City of Ottawa
Development Review Branch
Grading & Servicing Reviewed
Name: Bruce Bramah, EIT
Signed: 
Date: 09/27/2021

Owner/Applicant
DCR/PHOENIX HOMES
Telephone # 723-9227
Plan # 4M- 1618
Project name: PATHWAYS
Civic Address: 33 DUN SKIPPER DRIVE
House model: STRATHMORE A

SITE/GRADING PLAN
PATHWAYS PHASE 2

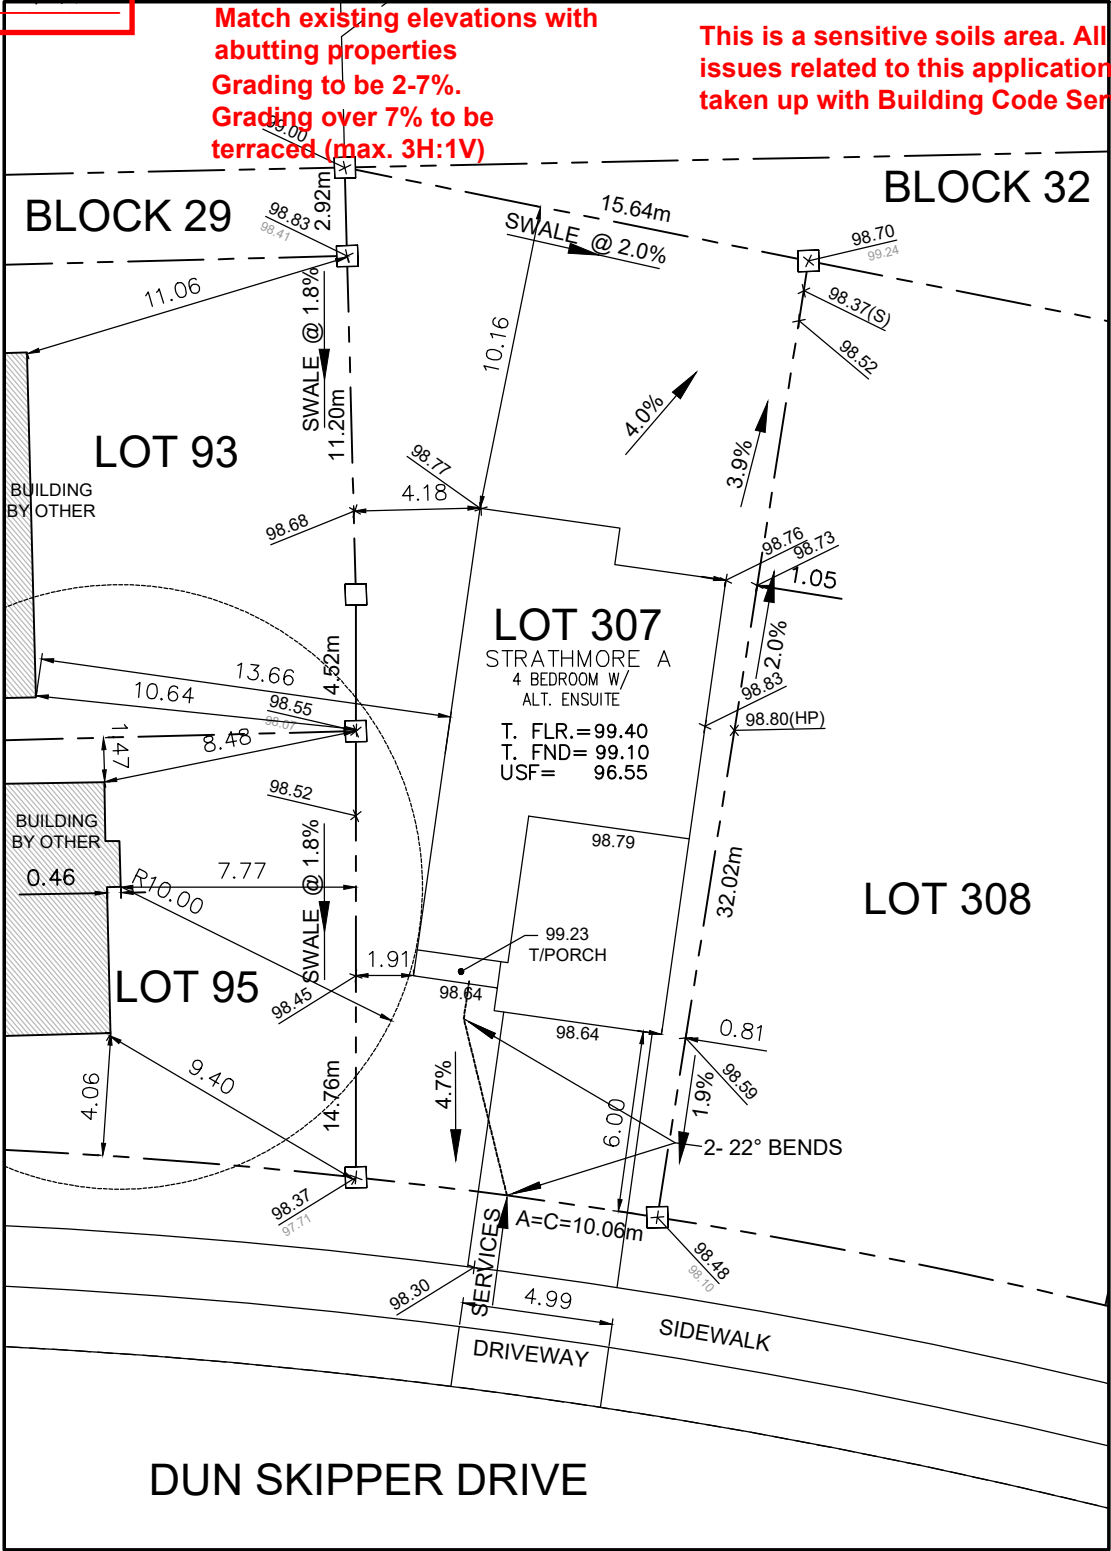
Sleeved services required under retaining walls / footings / garage, and are recommended under porches, decks, and similar structures
No excess drainage to be directed towards adjacent properties
Existing grading and drainage patterns must not be altered
Match existing elevations with abutting properties
Grading to be 2-7%.
Grading over 7% to be terraced (max. 3H:1V)

This is a sensitive soils area. All sensitive soil issues related to this application are to be taken up with Building Code Services

Maximum 2-22.5 degree horizontal radius bends for each service. Bends must be located on private property, spaced min. 1.0m apart, and 1.0m away from all valves

Top of water shutoff valve must be flush with asphalt if installed within driveway
